# RotorSport UK Ltd

## Service Bulletin

| <b>SB No.: 027 issue 1</b>  | CCAR No.: None   | Classification:<br><del>OPTIONAL</del> or<br><b>RECOMMENDED</b> or<br><del>MANDATORY</del> |
| Aircraft type & model<br>(applicability)<br>RotorSport UK MT-03and<br>MTOsport series | Aircraft serial Nos. effected<br>RSUK/MT-03/all<br>RSUK/MTOsport all |  |

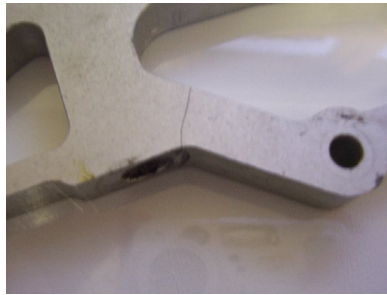
1) A small number of Pre-rotator Brackets RSD5023 have failed in service by way of a fine crack, originating at a mounting-screw hole and passing across a web – see photo below:

This crack would not result in a flight safety issue but may cause vibration and incorrect function of the pre-rotator. Can be resolved by replacement of Pre-rotator Bracket part number RSD5023 by M.PR01.06.01. (Modification Classification MC-128 refers).

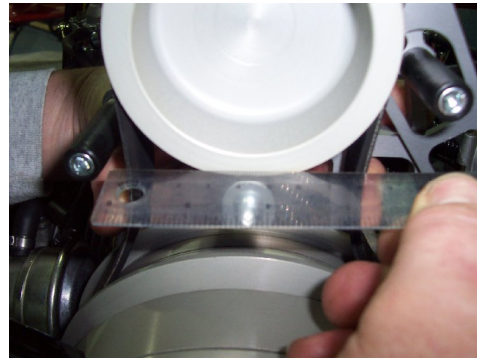
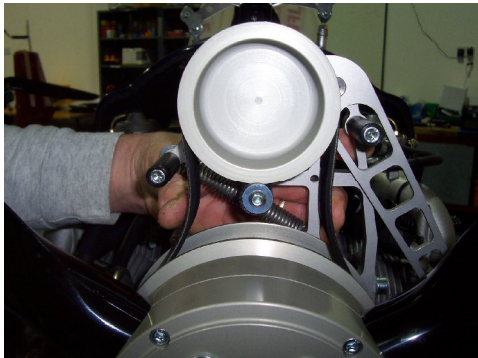
- (i) With air cylinder fully extended grip the belt firmly between finger and thumb.
  - (ii) Using a small rule positioned above the brake sleeve measure between the outer edges of the belt at its narrowest point. The distance should be 88 – 90mm as shown in the photos below

Checking the belt tension

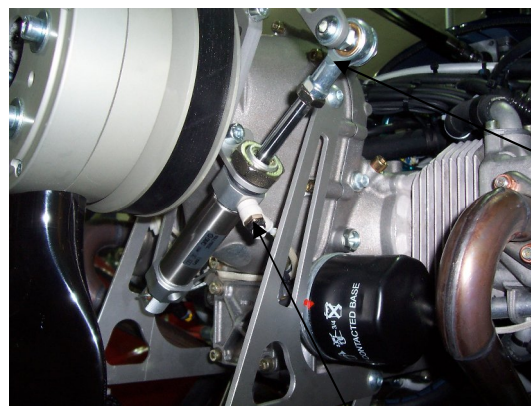
The rod-end moved to achieve belt tension

The restrictor used to adjust the rate of engagement of the Pre-rotator system
